Addendum No. 001

Subject: George W. Childs School – Classroom Modifications
SDP Contract Nos. B-071C, B-074C of 2017/18

This Addendum, dated May 9, 2018, shall modify and become part of the Contract Documents for the work of this project. Any items not mentioned herein, or affected by, shall be performed strictly in accordance with the original documents.

DRAWING NO.
ED122

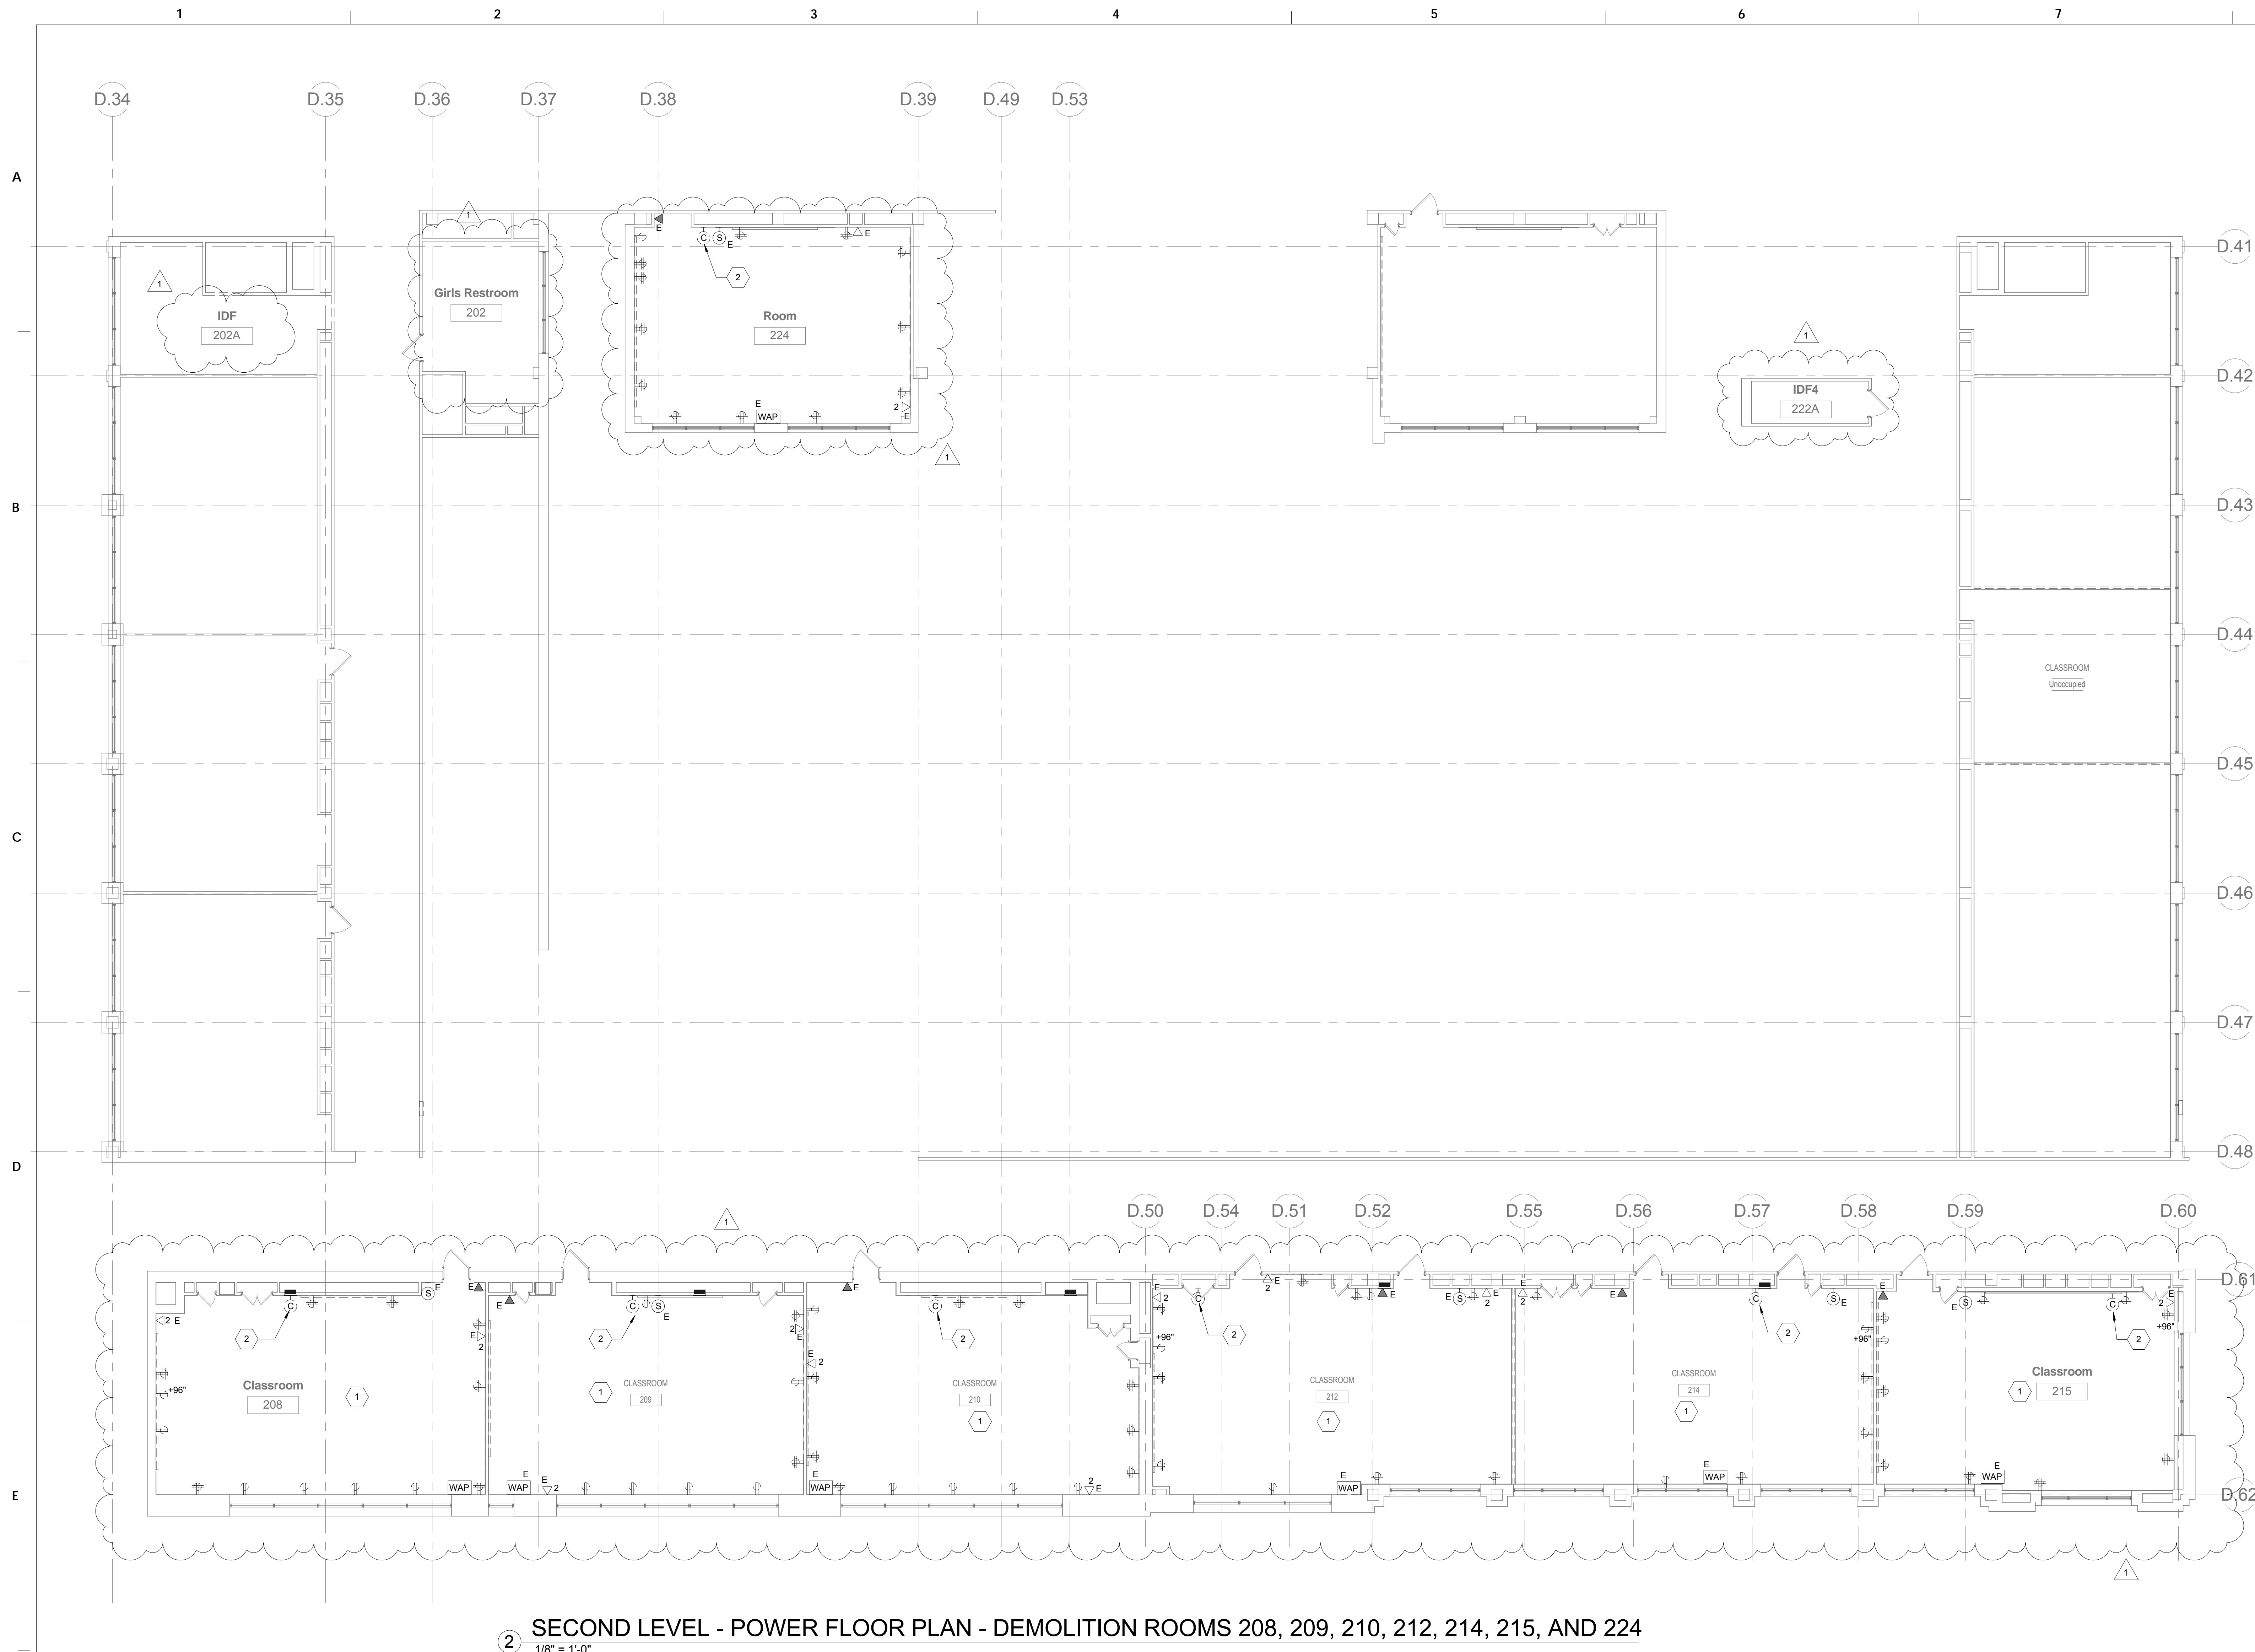
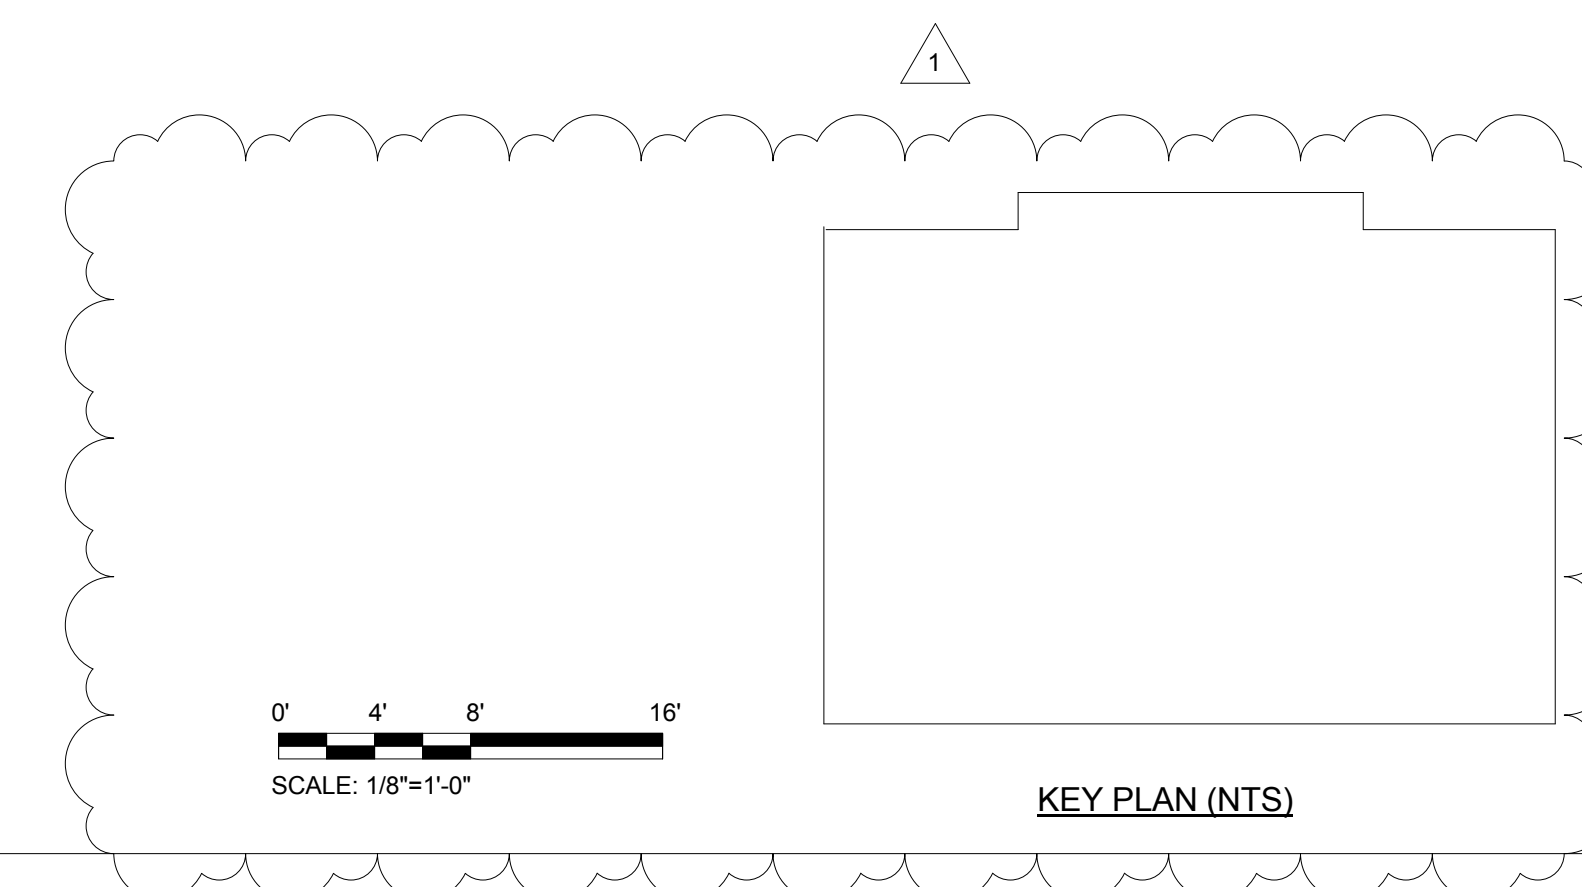
- a. Added existing receptacle and data layout in rooms 208, 209, 210, 212, 214, 215 and 224.
- b. Added IDF3 room 202A, IDF4 room 222A and Girls Restroom 202.
- c. Added key note 1.
- d. Added key plan, graphic scale and north arrow.

DRAWING NO.
E101

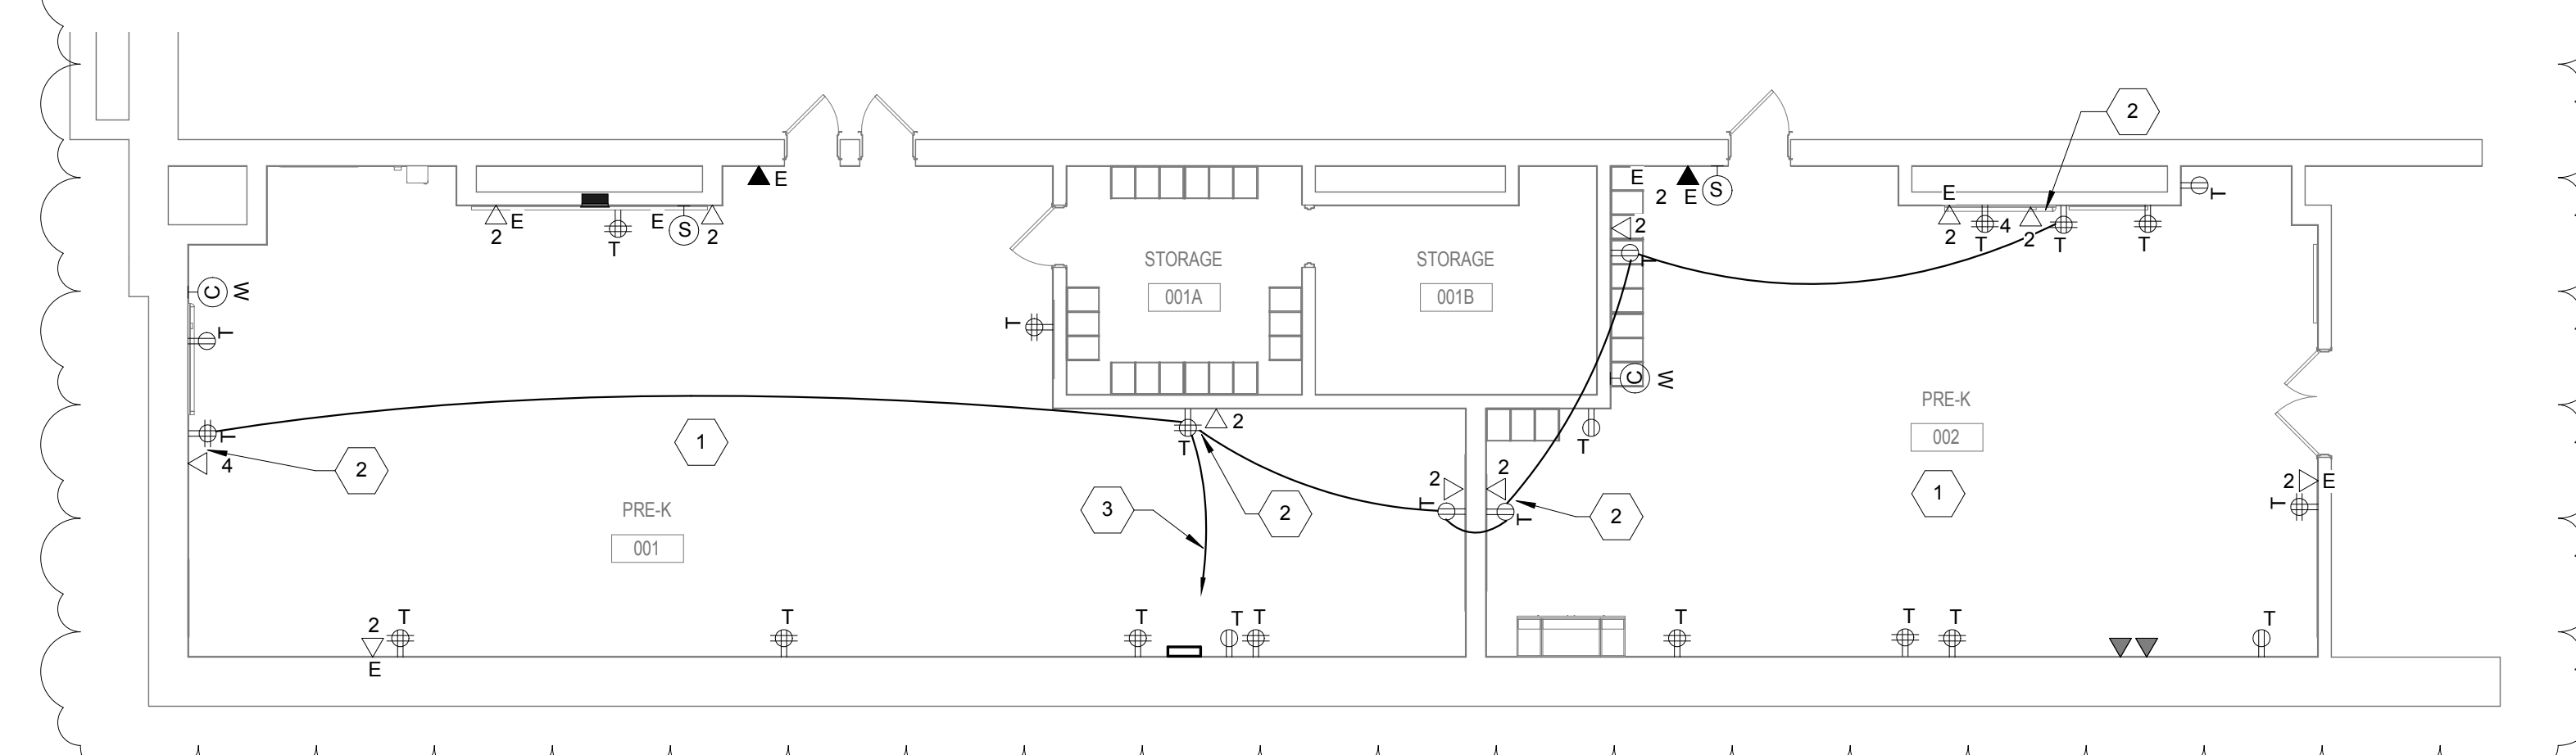
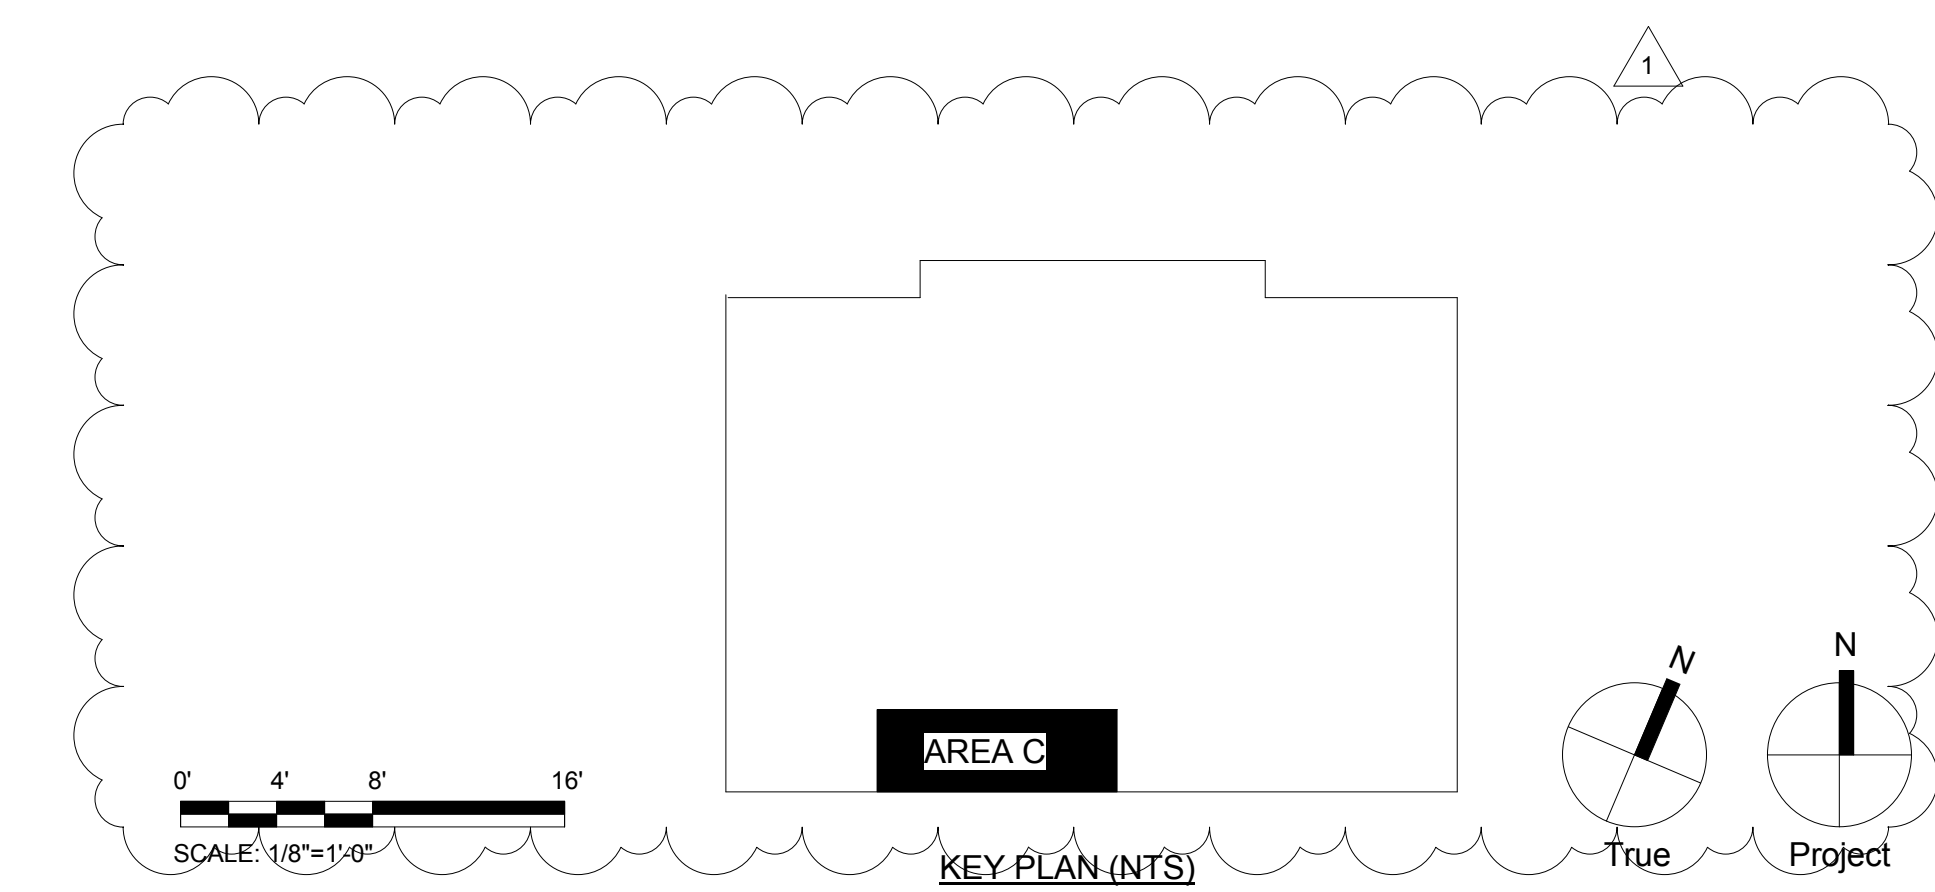
- a. Revise lighting and power layout in rooms 001 and 002.
- b. Added key plan, graphic scale and north arrow.
- c. Add key notes 1, 2 and 3.
